NMP2L2611

January 8, 2016

> Nine Mile Point Nuclear Station, Unit 2 Renewed Facility Operating License No. NPF-69 NRC Docket No. 50-410

- Subject: Response to Request for Additional Information by the Office of Nuclear Reactor Regulation to Support Review of Nine Mile Point Nuclear Station, Unit 2, Relocation of Secondary Containment Bypass Leakage Paths Table from Technical Specifications to the Technical Requirements Manual
- References: 1. Letter from J. Barstow (Exelon Generation Company, LLC) to U.S. Nuclear Regulatory Commission, "Relocation of Secondary Containment Bypass Leakage Paths Table from Technical Specifications to the Technical Requirements Manual," dated March 23, 2015.
 - Letter from Brenda Mozafari (Senior Project Manager, U.S Nuclear Regulatory Commission) to Mr. Bryan Hanson (Exelon), "Nine Mile Point Nuclear Station, Unit 2 - Request for Additional Information Regarding (CAC MF5900)," dated December 17, 2015.

TS Pages 3.6.1.3-1, -12, -14 and -15 Bases Pages B3.6.1.3-1 through -3 TRM Pages 3.6-23a and -23b

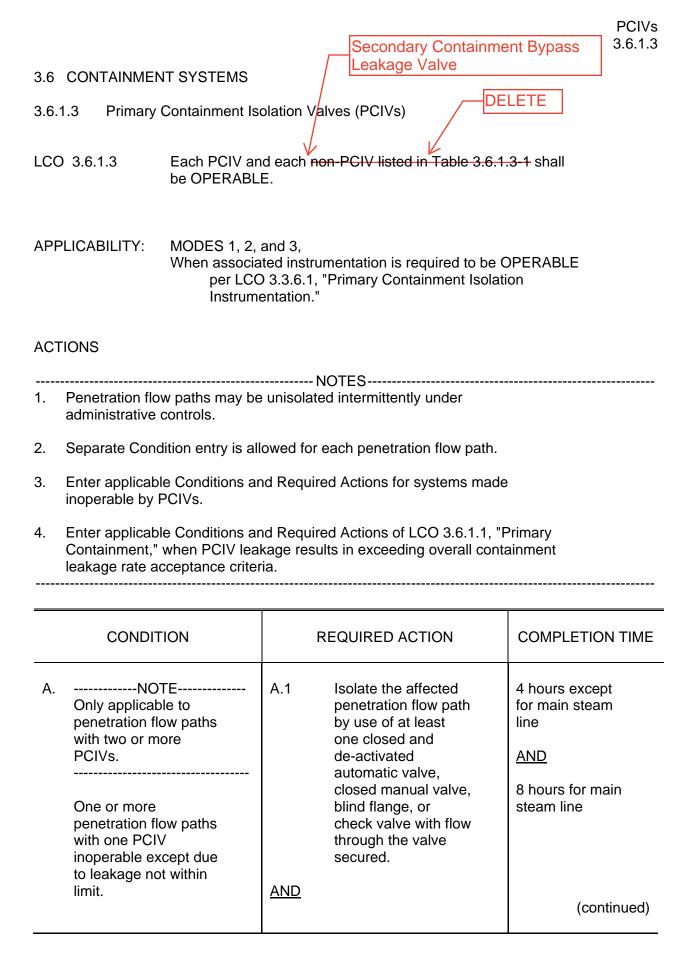
The information from this Technical Specification section has been relocated to the TRM and maintained in accordance with the 10 CFR 50 Appendix J Testing Program Plan.

PCIVs B 3.6.1.3

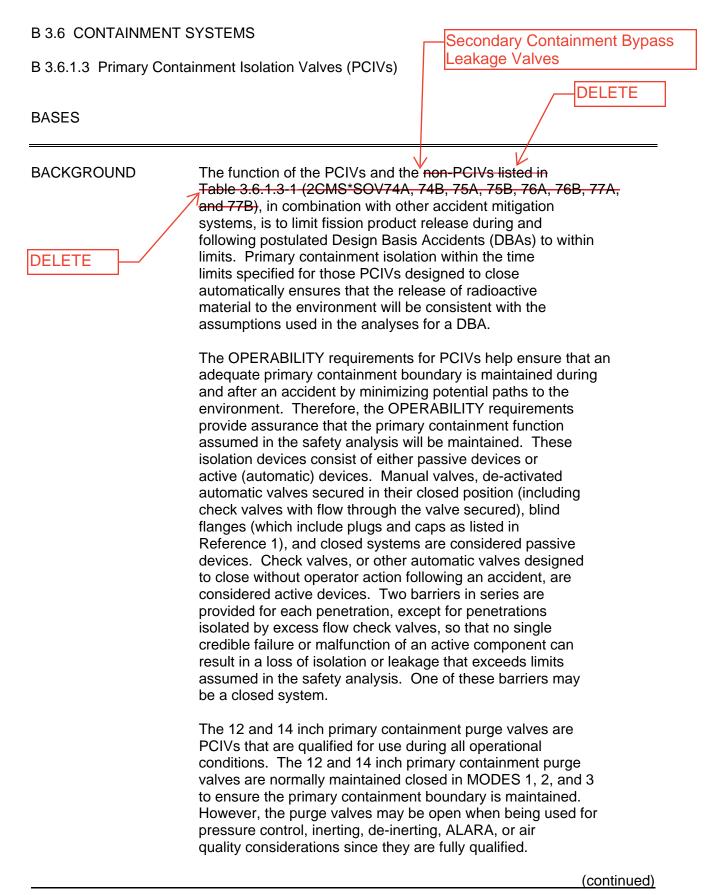
The Secondary Containment Bypass Leakage paths leakage rate limits are relocated to the Technical Requirements Manual (TRM) Table 3.6.1-3 and the Alternate Source Term (AST) established leak rate values are maintained in accordance with the 10 CFR 50 Appendix J Testing Program Plan.	limiting event due to radiological consequences. In addition, the non-PCIVs listed in Table 3.6.1.3-1 are also assumed to be closed during the LOCA. The closure time of the main steam isolation valves (MSIVs) is a significant variable from a radiological standpoint. The MSIVs are required to close within 3 to 5 seconds since the 3 second closure time is assumed in the MSIV closure (the most severe overpressurization transient) analysis (Ref. 4) and 5 second closure time is assumed in the MSLB analysis (Ref. 3). Likewise, it is assumed that the primary containment isolates such that release of fission products to the environment is controlled.
